STAFF REPORT
KETCHUM PLANNING AND ZONING COMMISSION
NOVEMBER 28, 2023 MEETING

PROJECT: 490 Wood River Dr Residence

FILE NUMBER: P23-029

REQUEST: Floodplain Development Permit for a new 10,636 square foot residence and modification of wetland areas.

FLAP GATE - SHALL BE 8" DIAMETER ALUMINUM FLAP GATE WITH NEOPRENE SEAT (OR EQUAL).

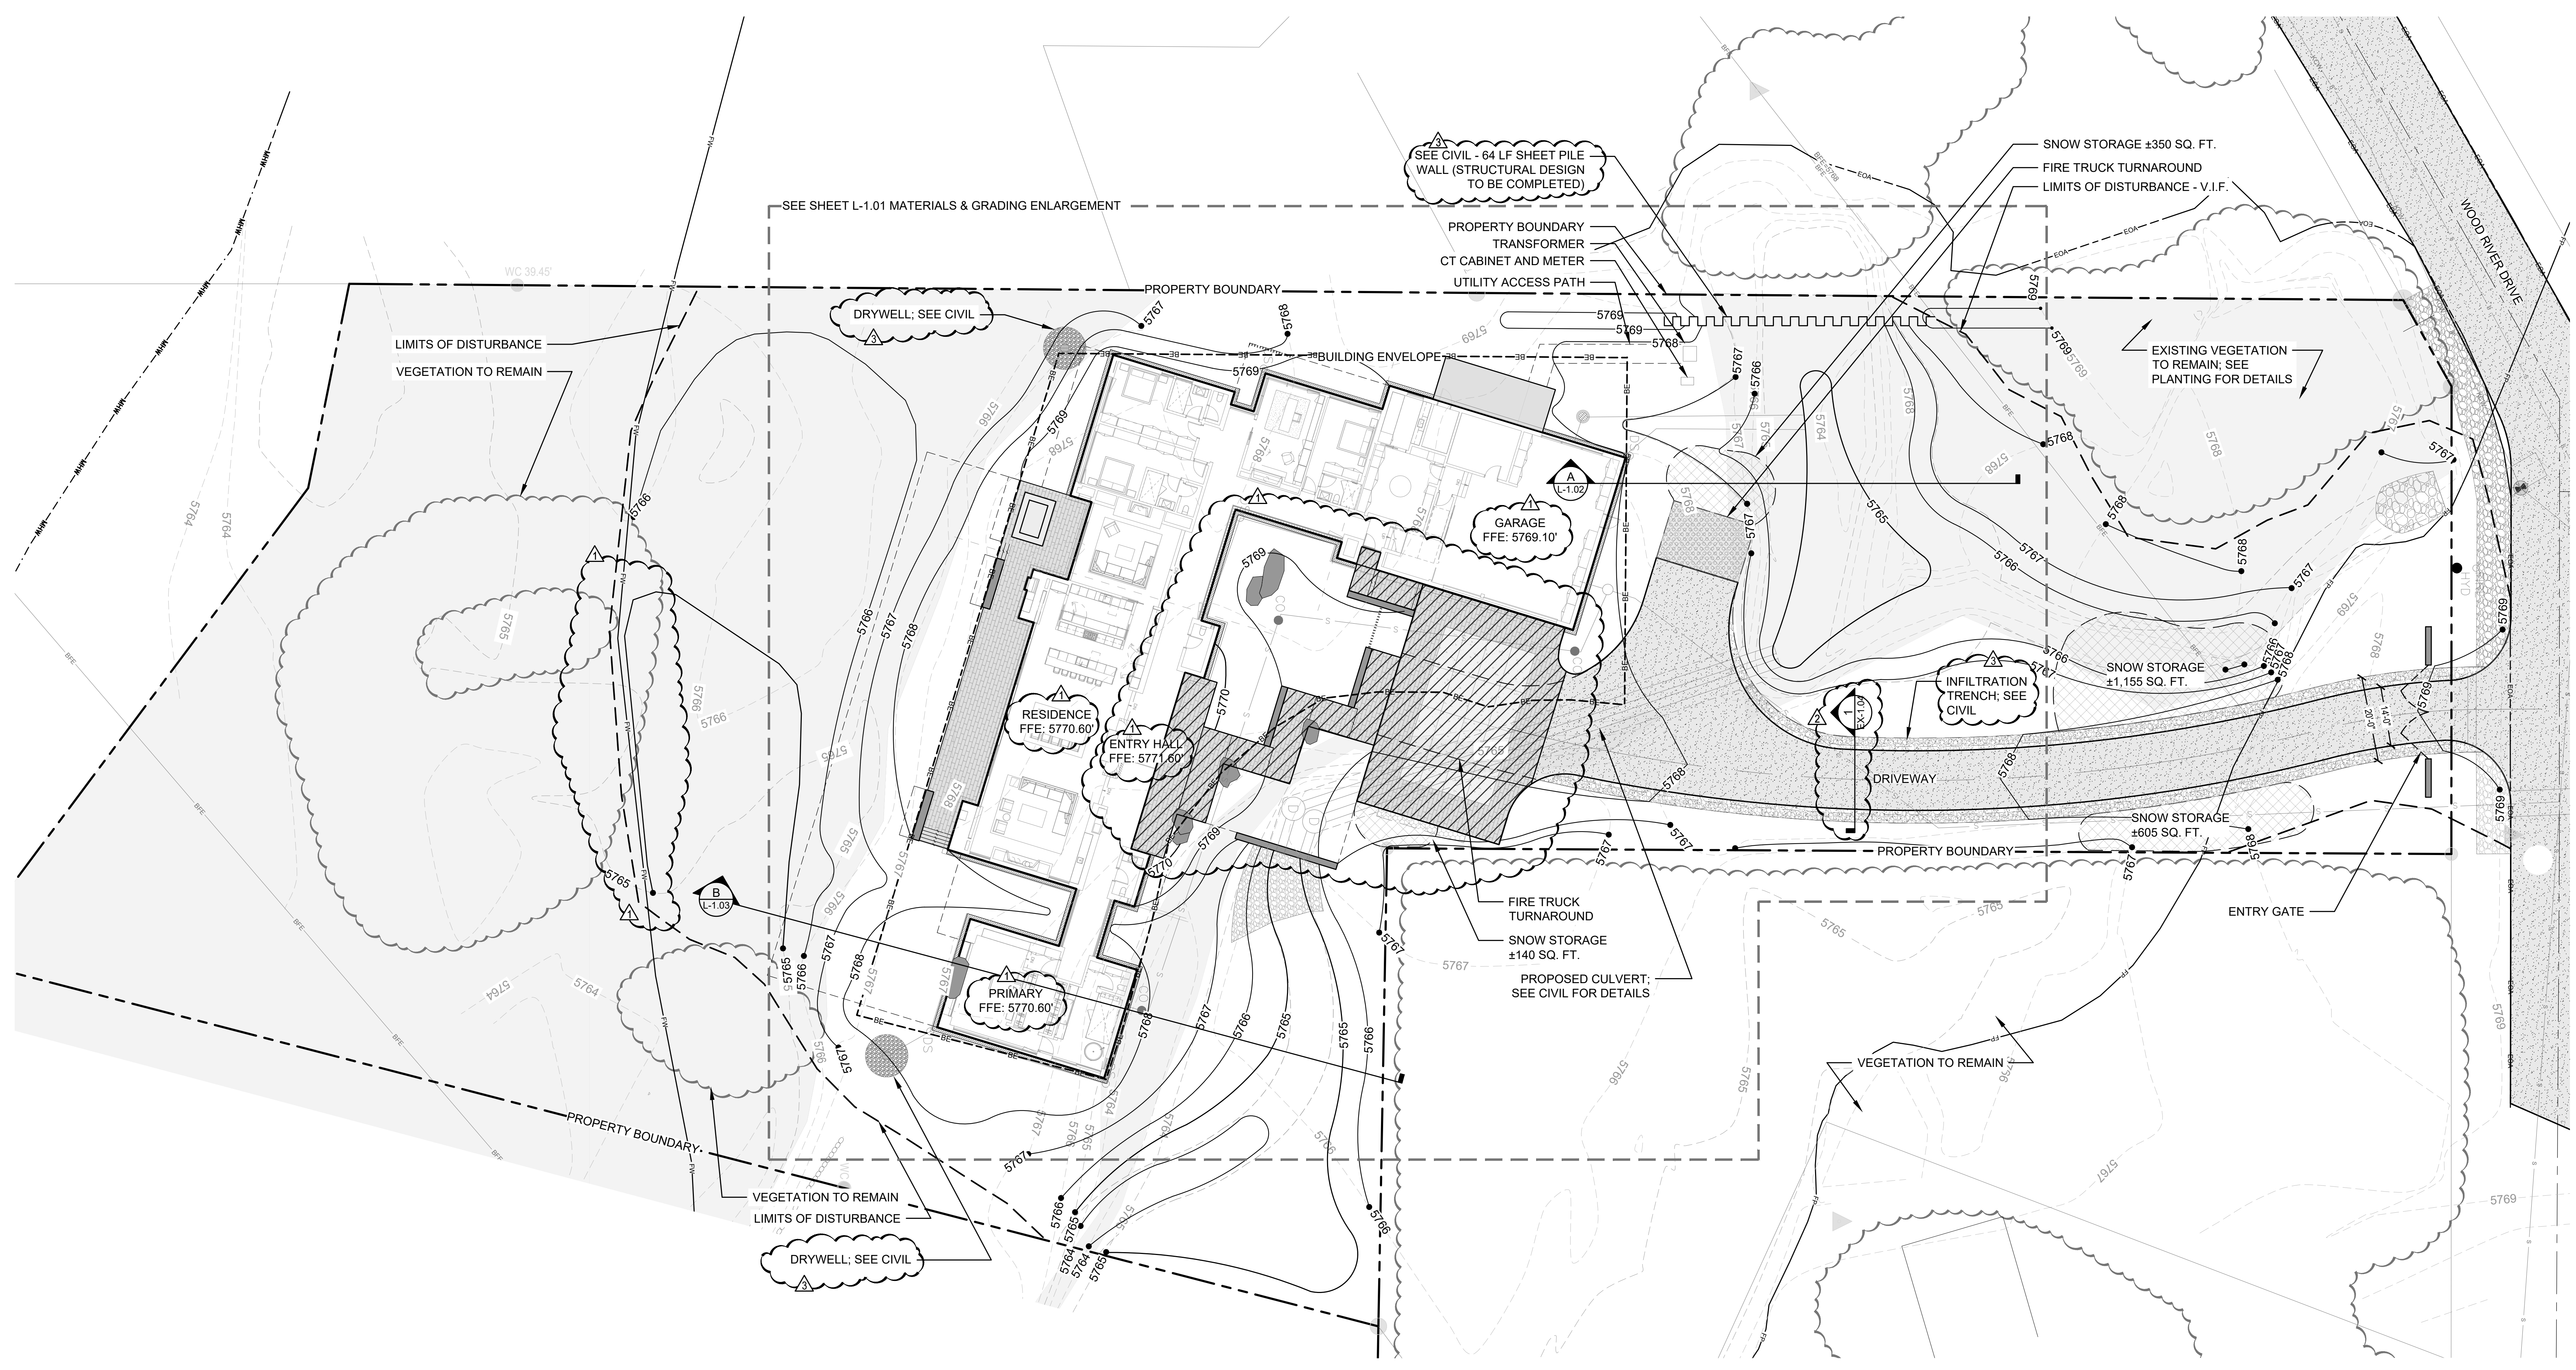
14. Flap gates installed within the sheet pile wall shall be kept clear of vegetation and other debris and must remain operable year-round. Additionally, the neoprene seals shall be maintained per the recommendations of the manufacturer and shall be replaced when it is found they do not function as intended by prohibiting water from backflowing through the flap gates.
15. Regional drainage channels and culverts shall be kept clear of any obstructions at all times to allow for drainage to move through the subject property as intended.
16. The realigned and reconfigured ponds and drainage channels as approved by this floodplain development permit shall be considered the ponds and drainage channels, and corresponding drainage easements, identified by plat note #4 of Mary's Place Subdivision.

SHEET 6 OF 7
L-2.00

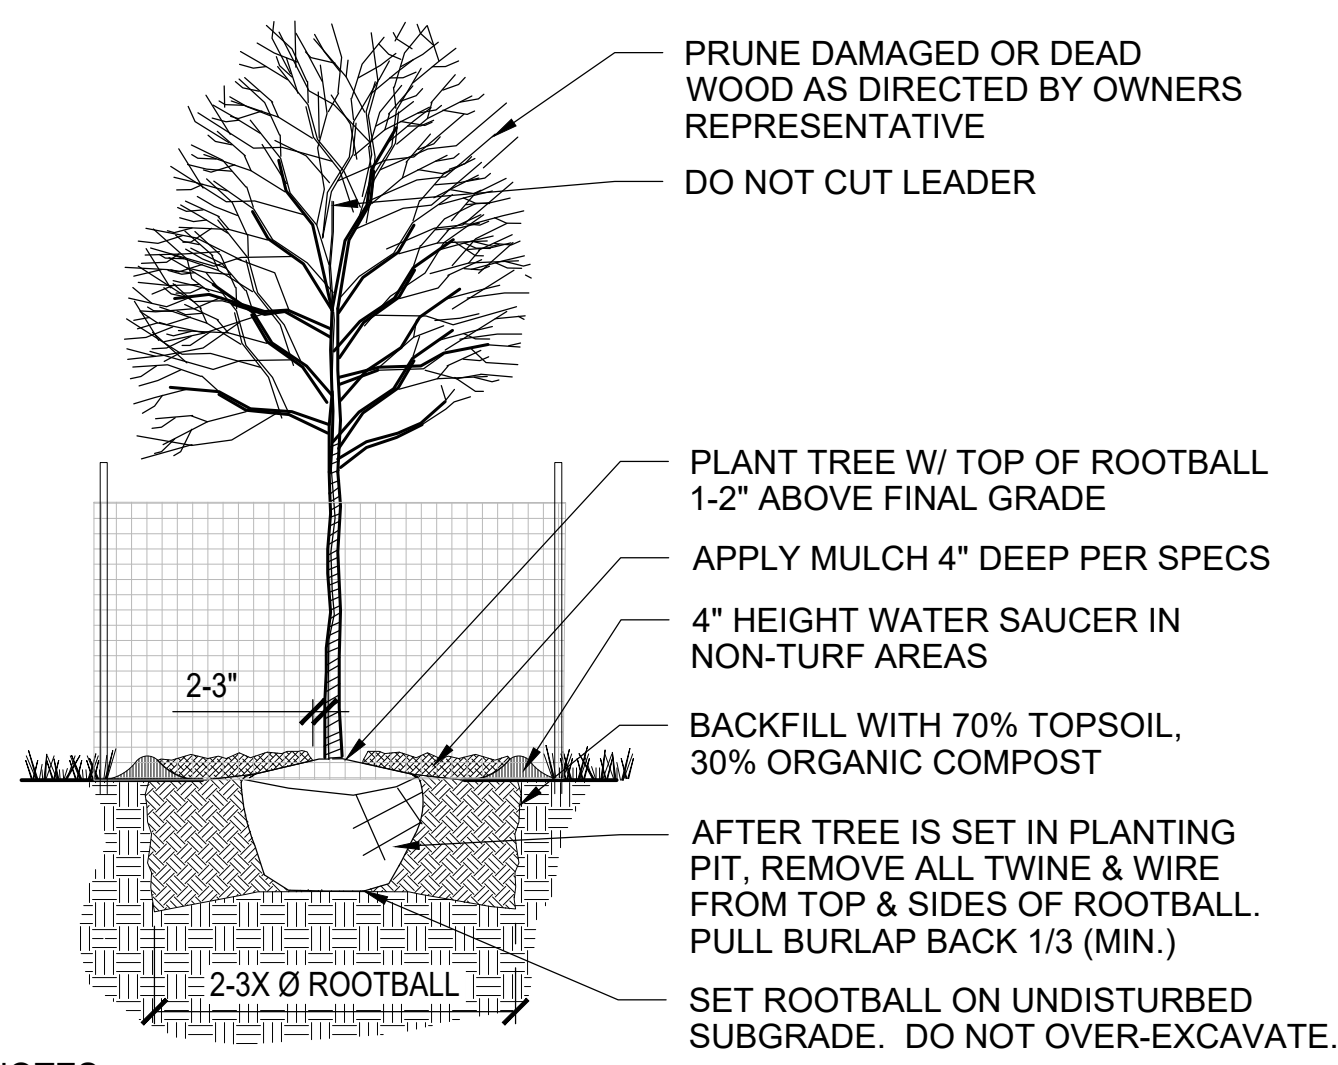
3. Follow up site visits to ensure compliance with the approved Landscaping Plan, L-2.00 dated 10/26/2023, are required for the three (3) years following the initial site visit that occurs in conjunction with issuance of the Certificate of Occupancy.

- a. If, upon an annual inspection, 80% or fewer of the plants indicated on Landscape Plan L-2.00 dated 10/26/2023 have not survived, the property owner shall re-install new plantings.
